Monitoring Report – Year 3
FINAL VERSION
Edwards-Johnson Mitigation Project
Calendar Year of Data Collection: 2020

RE: WLS Responses to NCDEQ DMS Review Comments for Task 9 Draft Monitoring Report Year 3 for the Edwards-Johnson Mitigation Project, NCDEQ DMS Full-Delivery Project ID #97080, Contract #006825, Neuse River Basin, Cataloging Unit 03020201, Johnston County, NC

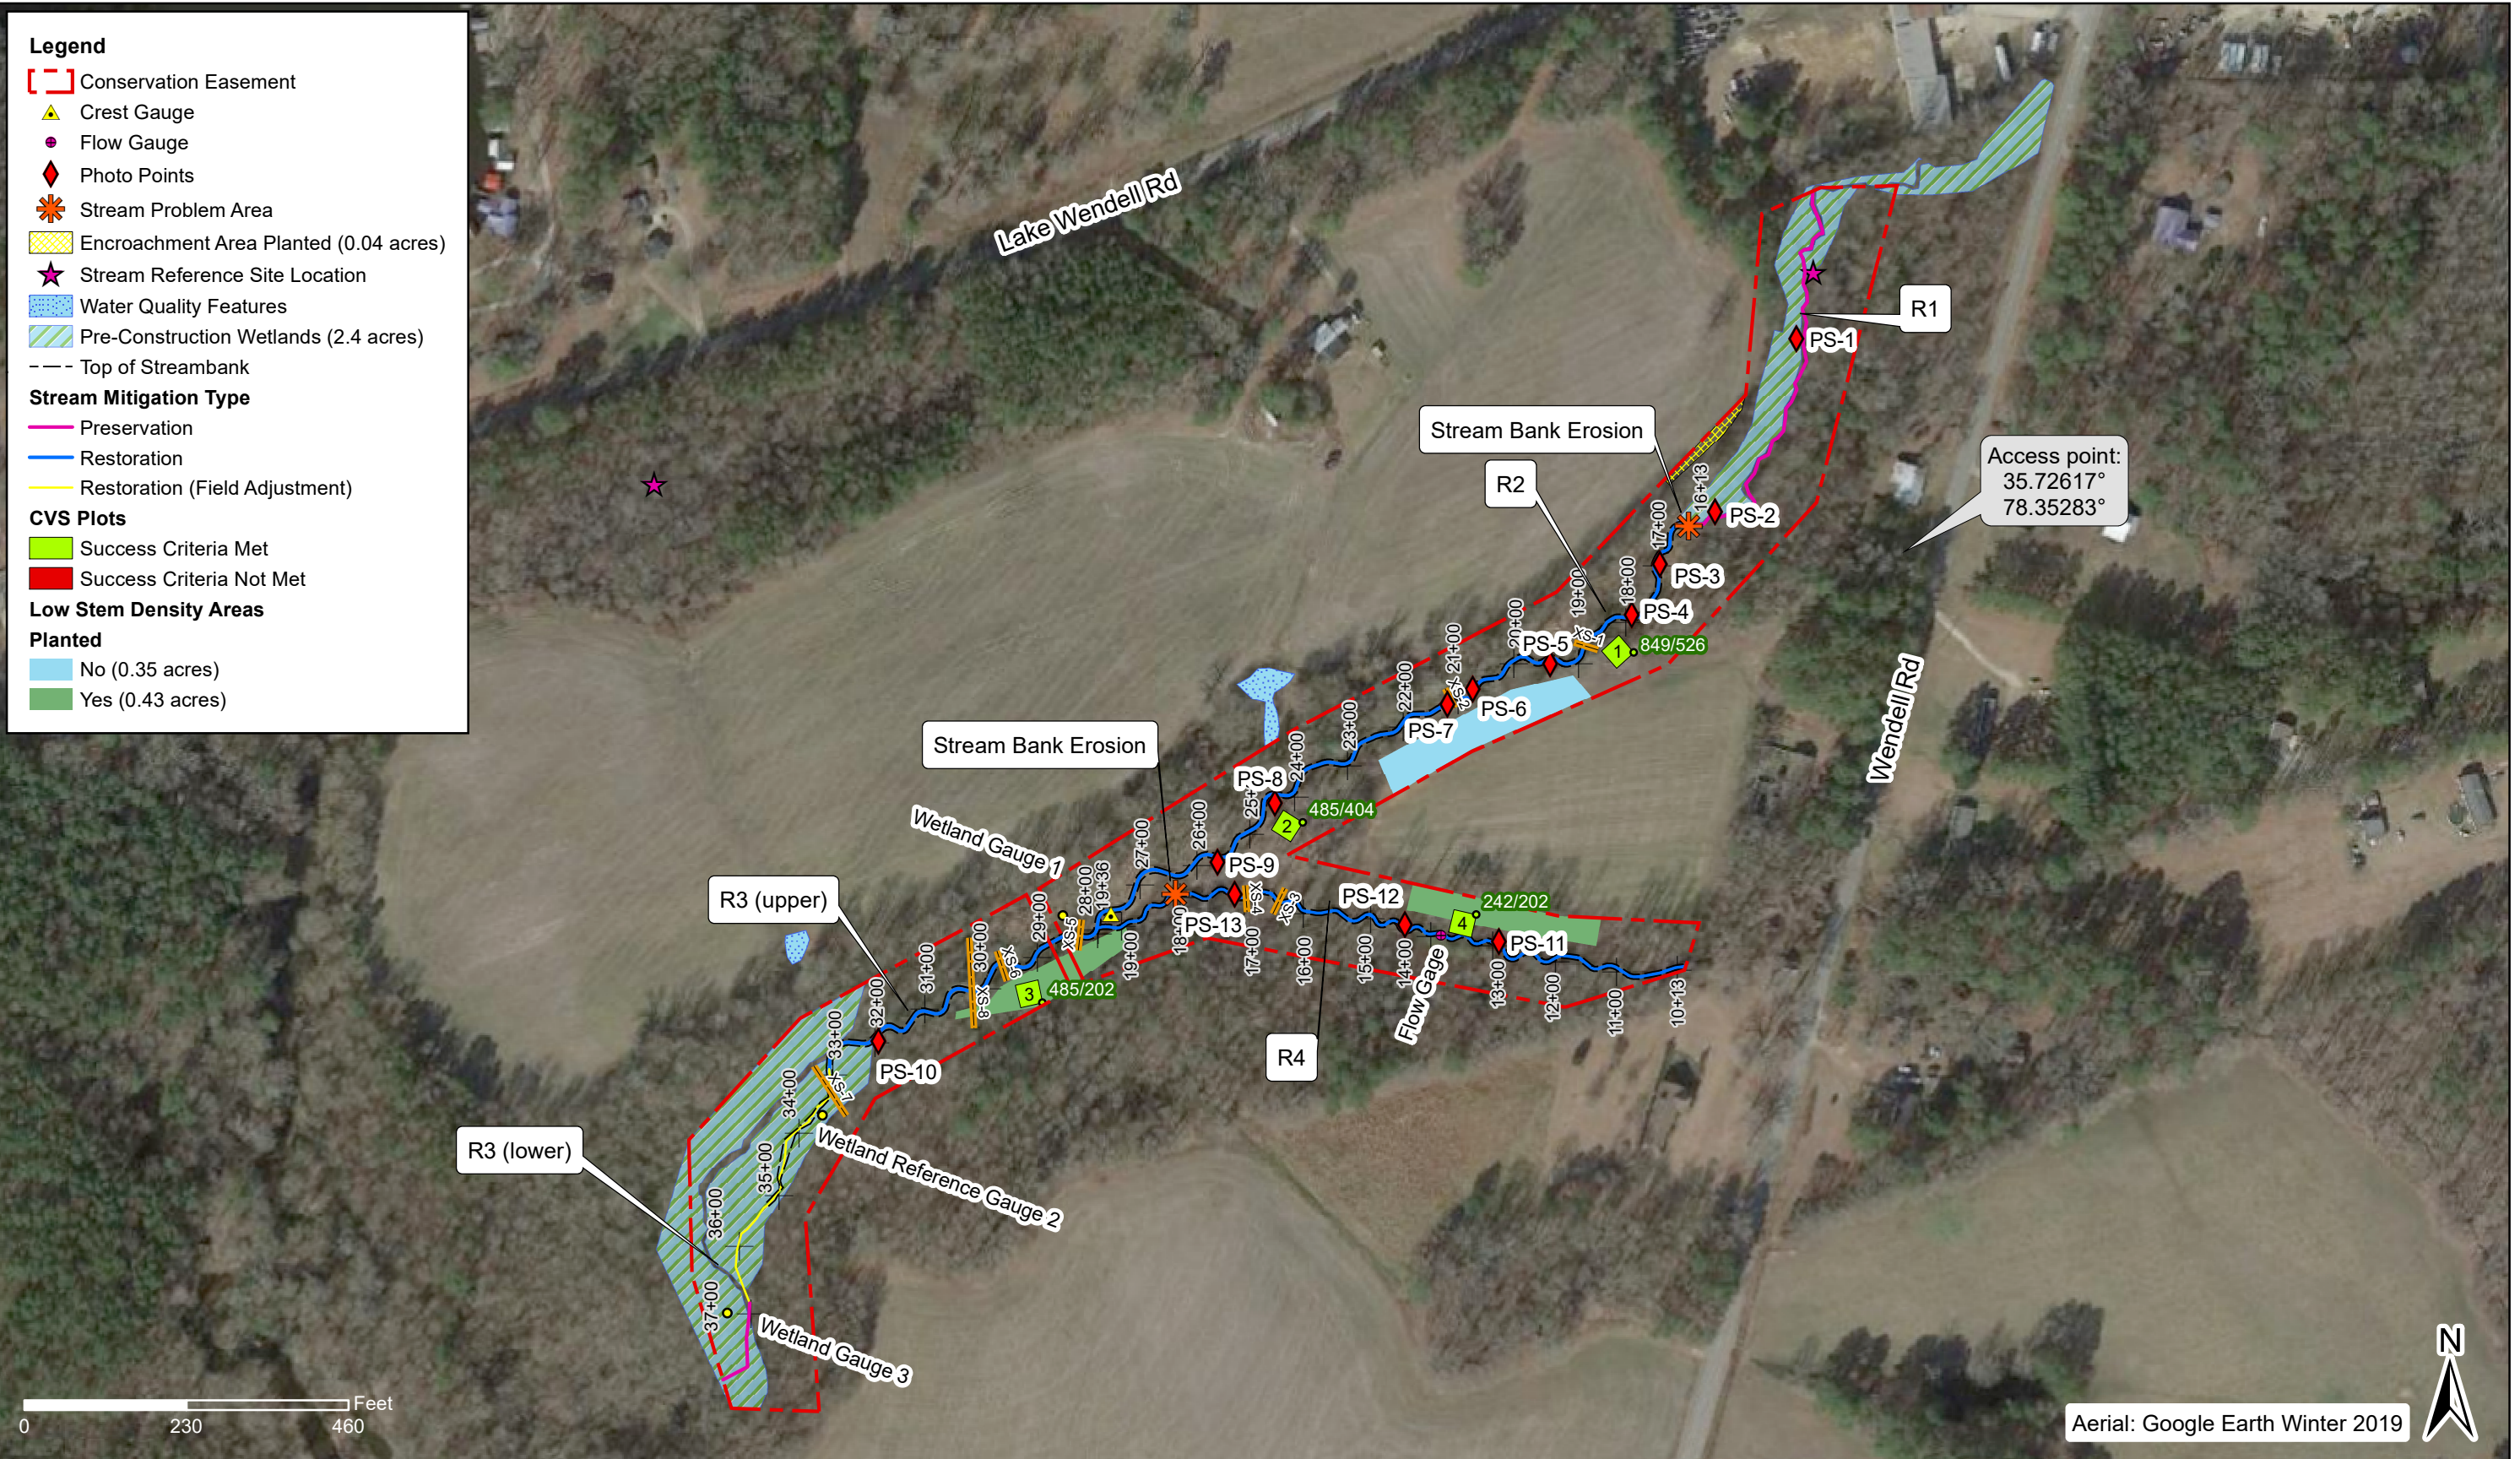
- 3. DMS Comment: The CCPV indicates areas of concern from MY2 were 0.43 (green shaded). Confirm that this is the acreage that was replanted with the ~245 plants (560 stems/acre)? Did WLS also replant the encroachment area along upper R1 (farm scallop)? If not, please add something to the text about the condition of that area.** WLS Response: The area on the CCPV that was replanted was ~0.43 acres (green) and

- 1. DMS Comment: Please provide the “stream problem area” and “encroachment area planted” shapefiles for the current monitoring year that were included in Figure 1.** WLS Response: The shapefiles for “stream problem area” and “encroachment area planted” are included in the e-data.
- 2. DMS Comment: Include the visual assessment photos as JPEGs rather than a single PDF.** WLS Response: JPEGs of all photos are now included in the e-data.

was planted with ~245 plants. The area of previous encroachment was planted in early 2019 and is in good vegetated condition (yellow).

Figure 5: Monthly Rainfall Data
Edwards-Johnson Mitigation Project (NCDEQ DMS Project ID# 97080)
MY3 2020

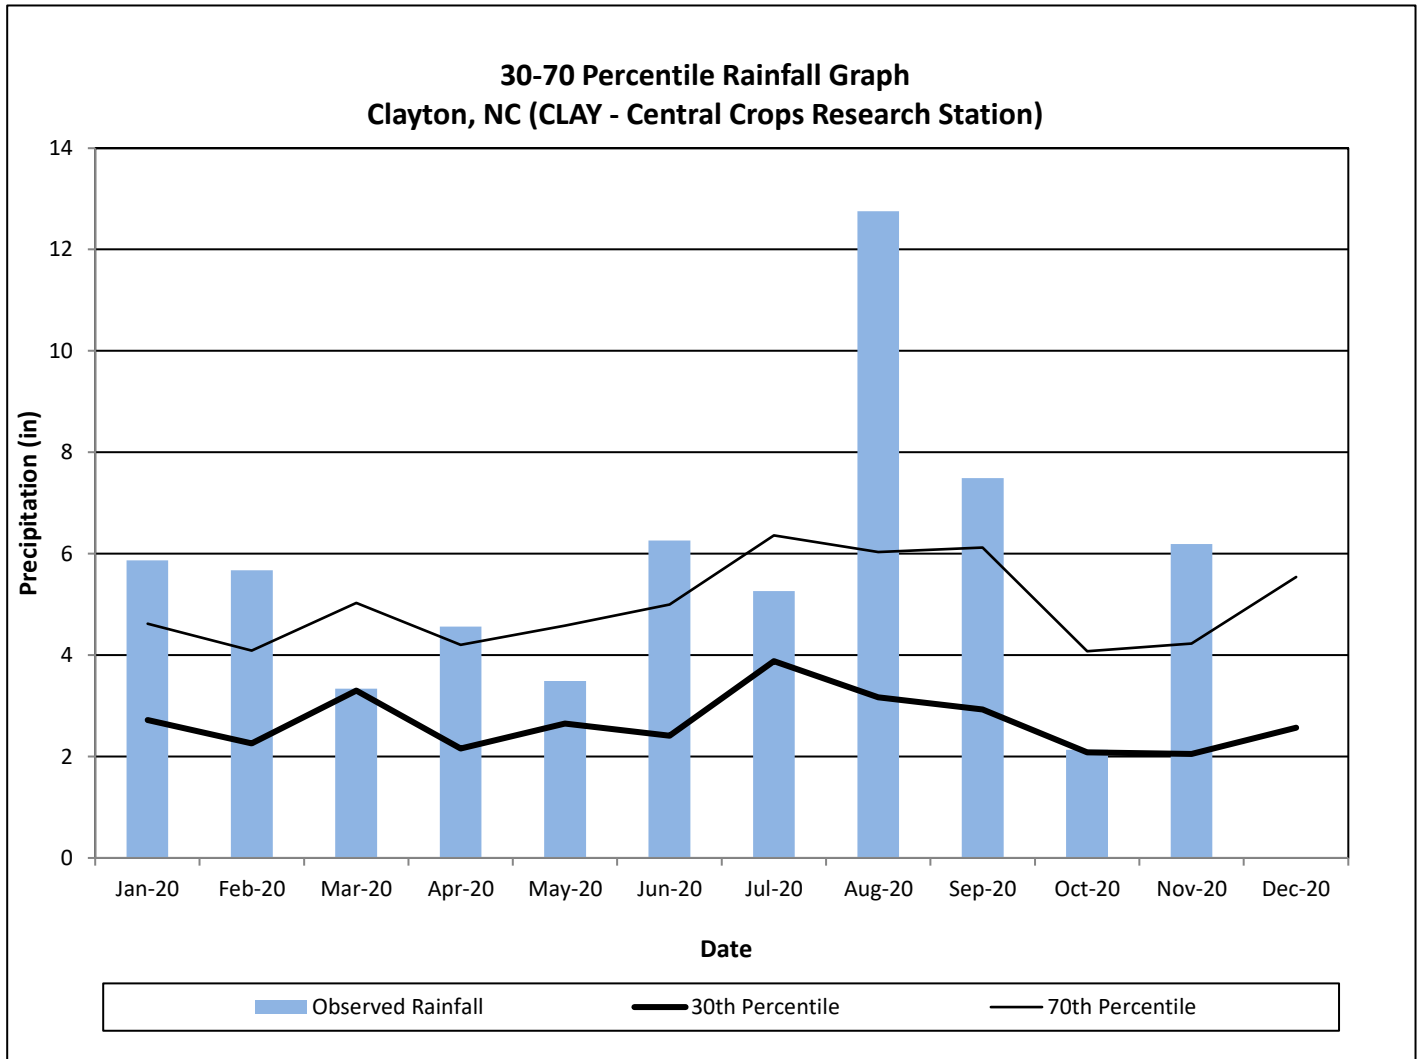
- 6. DMS Comment: Update rain report for October and November if possible.** WLS Response: WLS updated Figure 5 with the October and November rain total.
